NOTICE OF RECOMMENDATION

CITY OF GIG HARBOR DESIGN REVIEW BOARD PL-DR-17-0184

RE: PL-DR-17-0184 – Burnham Drive Apartments

Exhibit A

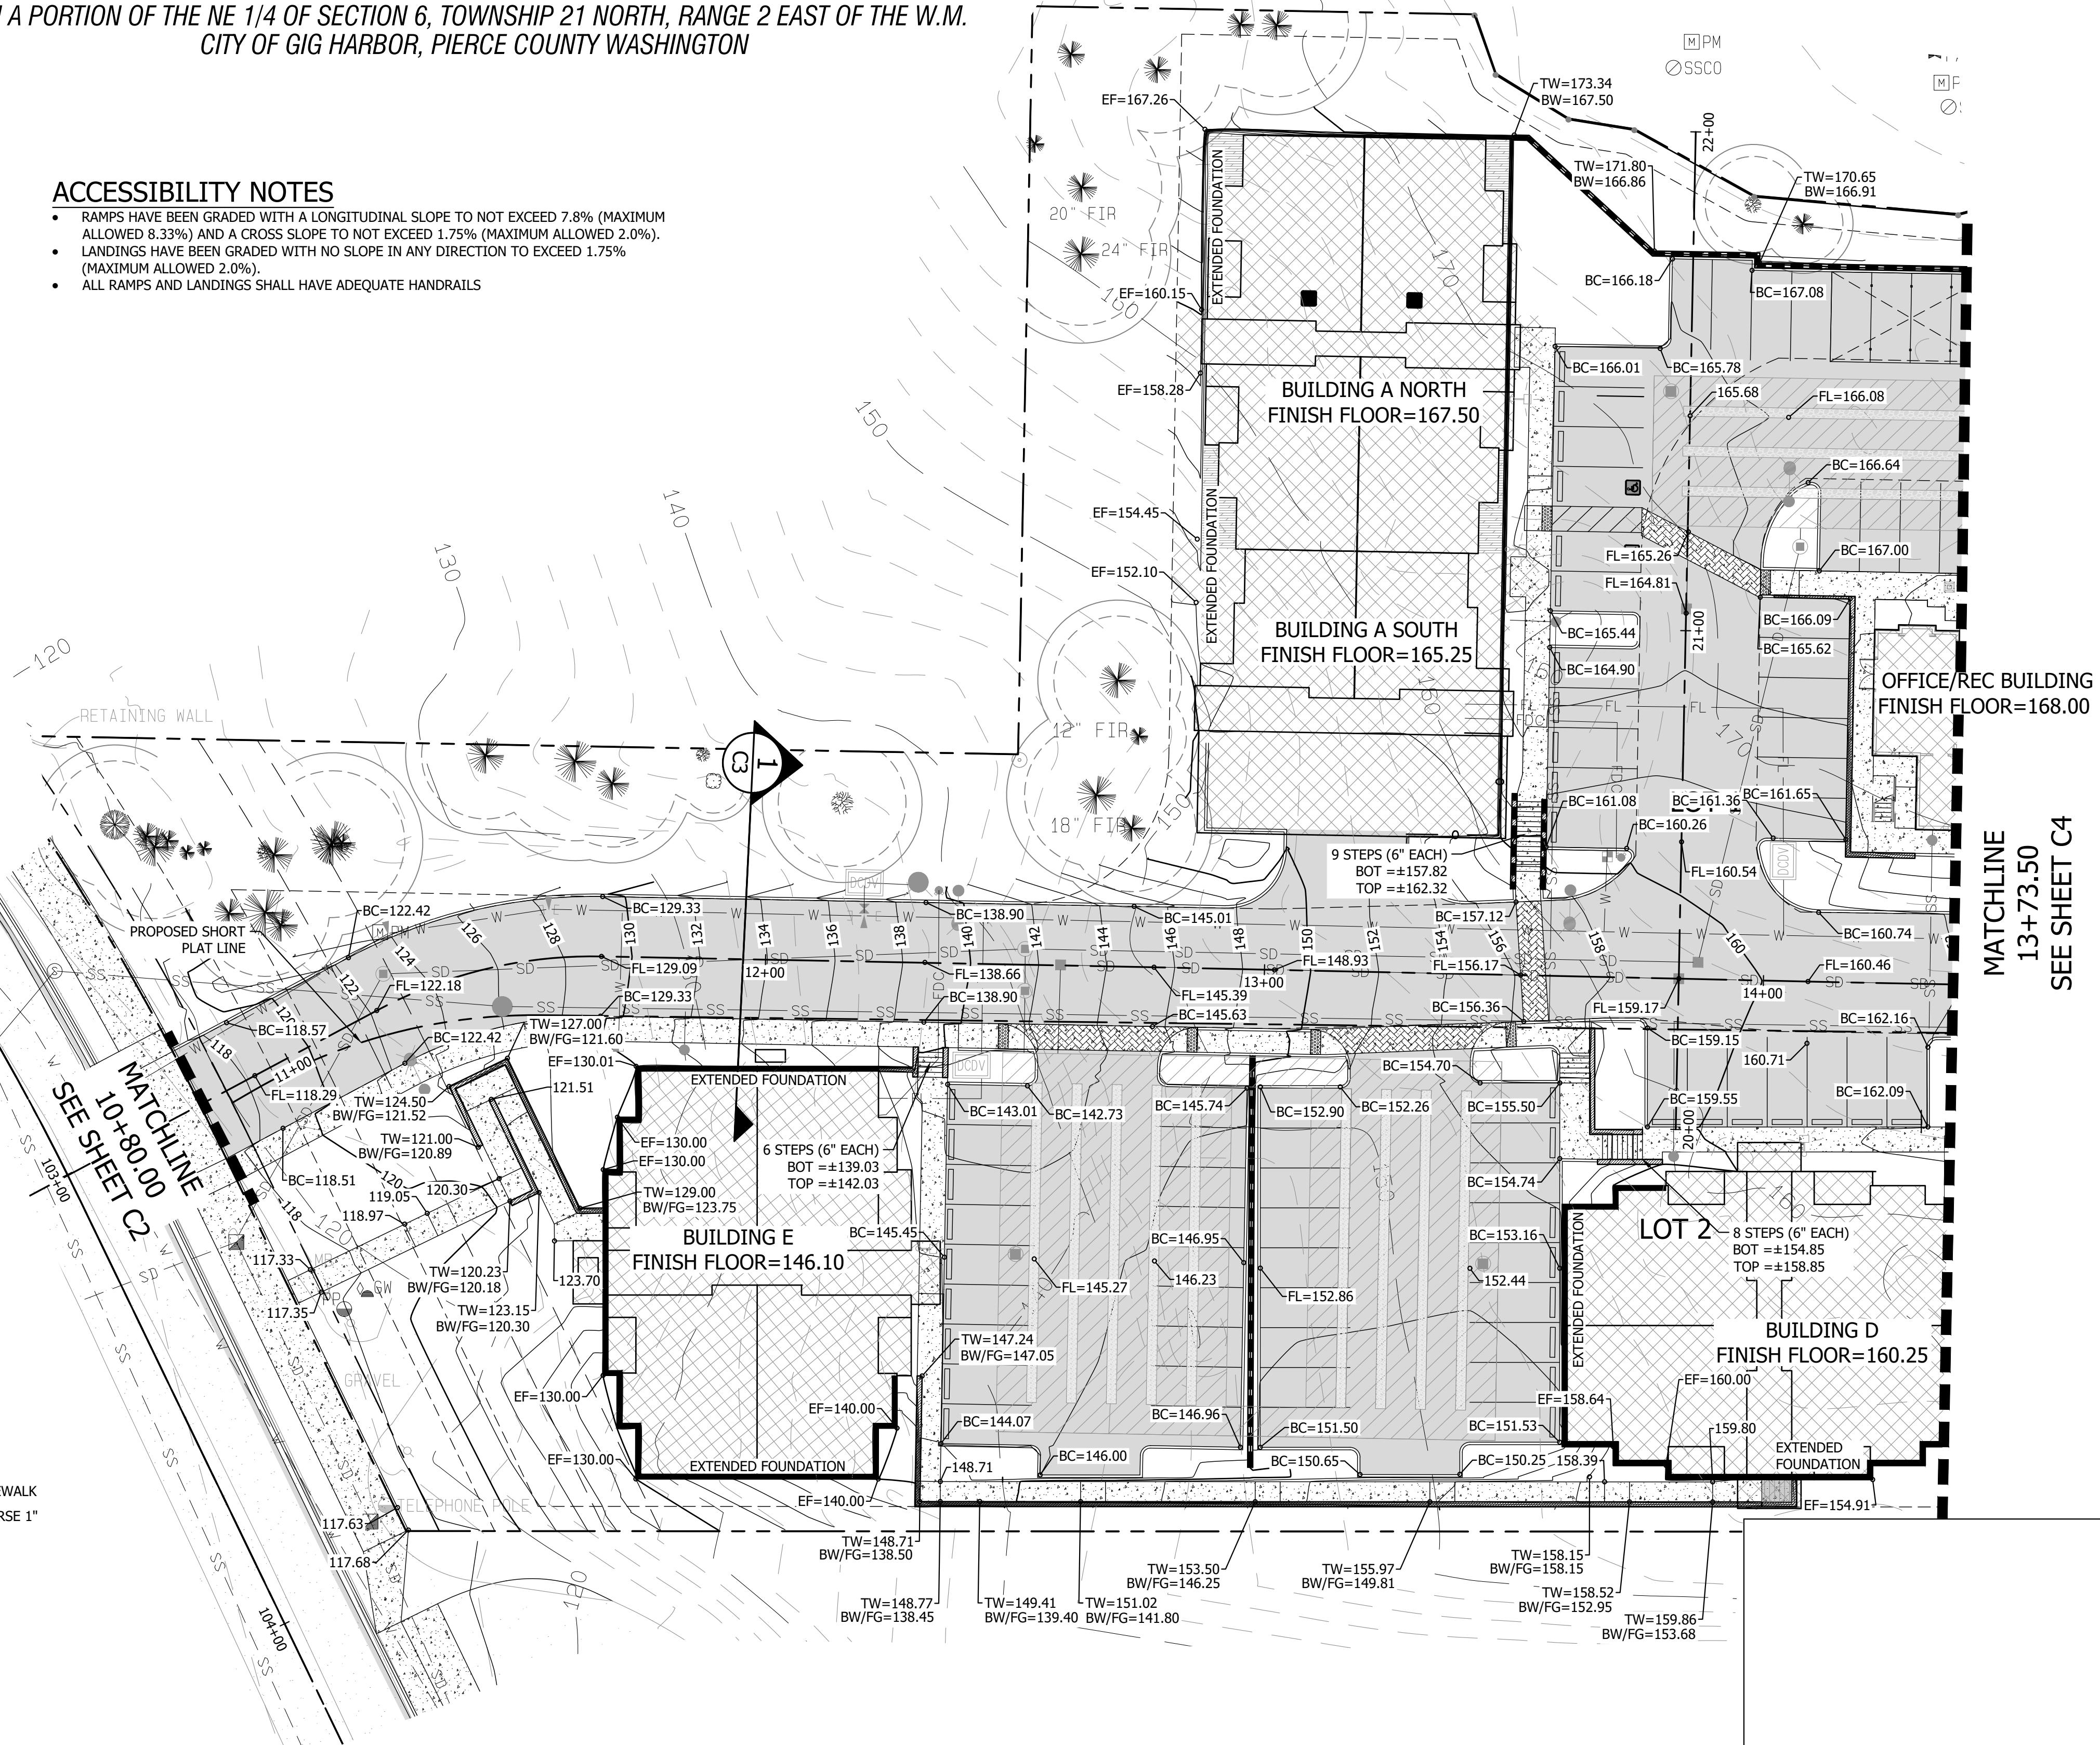
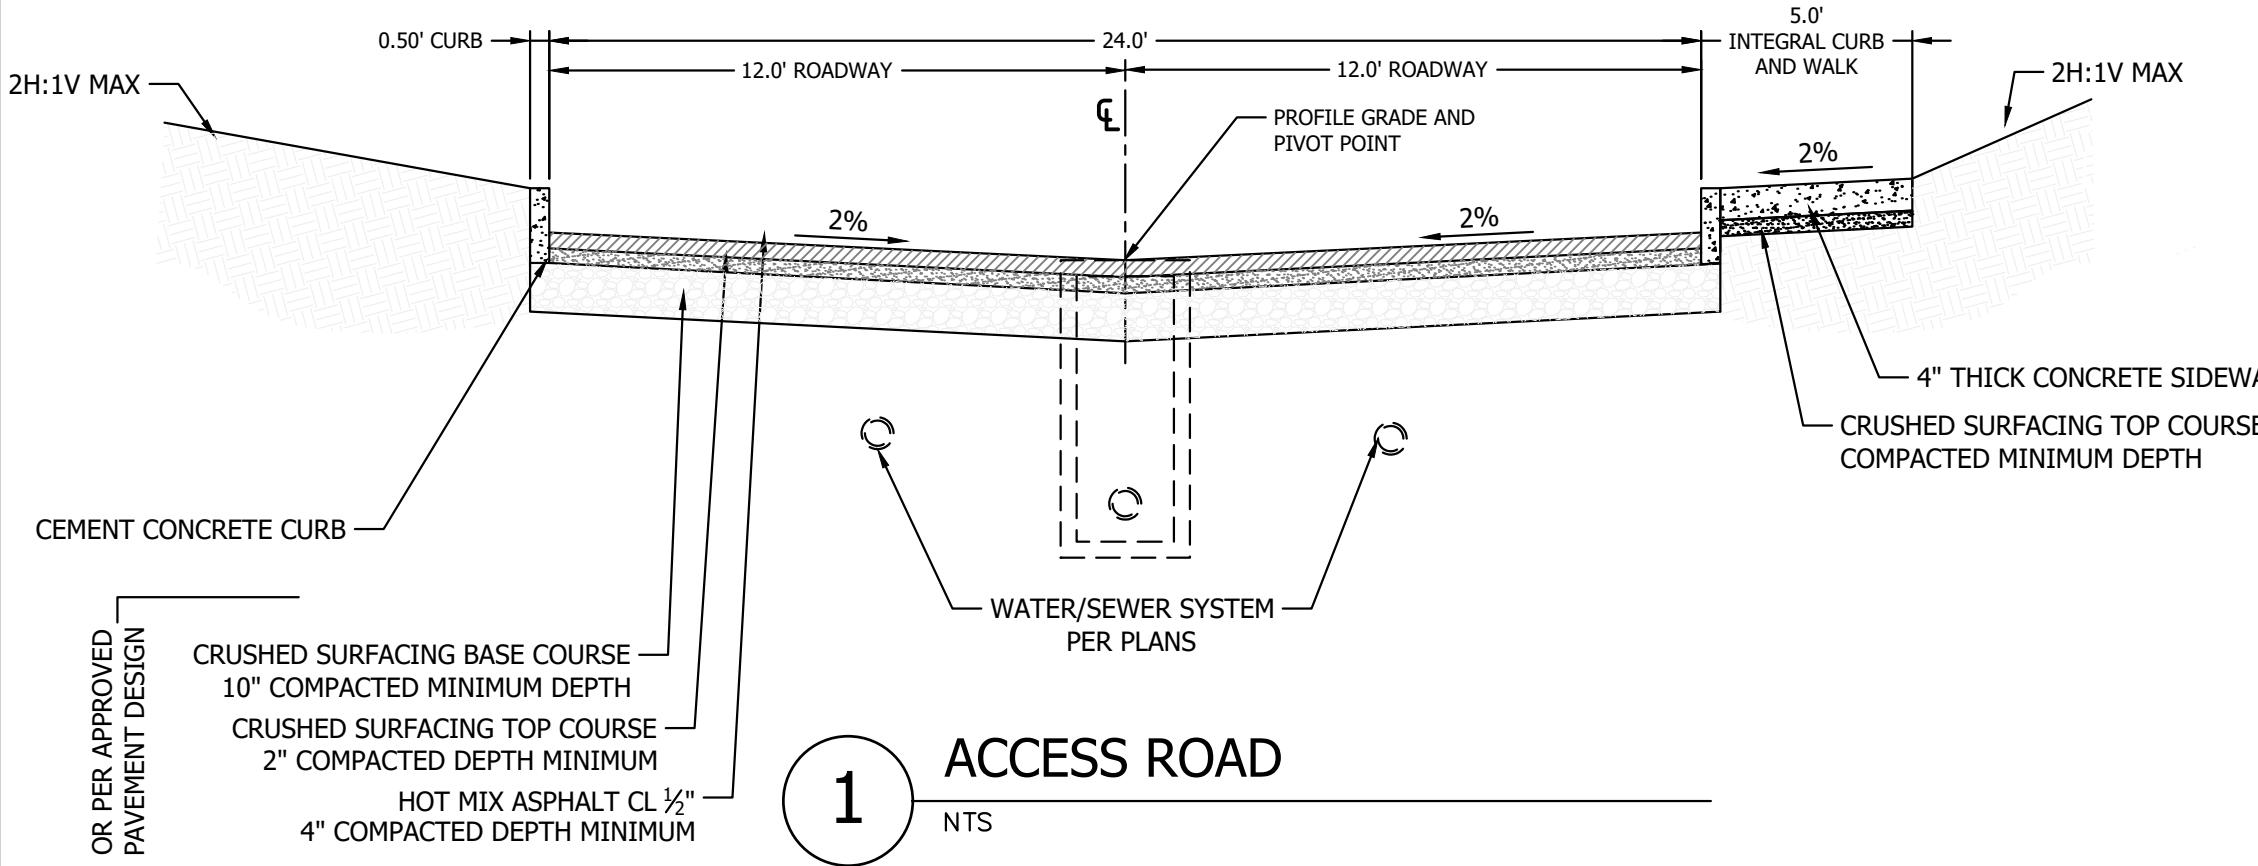
The DRB finds that the applicant's design alternative represents a site which maintains the natural topography of the site and incorporates structures into the natural slopes of the site. Particularly, the DRB finds that the applicant's incorporation of walls in excess of 6', as was demonstrated on Exhibit A to this recommendation, achieves an equivalent design to that which would be achieved through strict adherence to GHMC 17.99.240(C) and GHMC 17.99.370(A) as the walls support an accessible path which avoids the use of lifts.

Recommendation: The Design Review Board recommends the decision maker accept the proposed design alternative to GHMC 17.99.240(C) as consistent with the criteria of approval for an alternative design request set forth in GHMC 17.98.055(A), provided the applicant design its retaining walls as depicted in Exhibit A, and provided the site is graded consistent with the applicant's design proposal, as follows:

- Cut 14,315 cubic yards of material and fill 8,735 cubic yards of material, representing a 40% difference in grading quantities
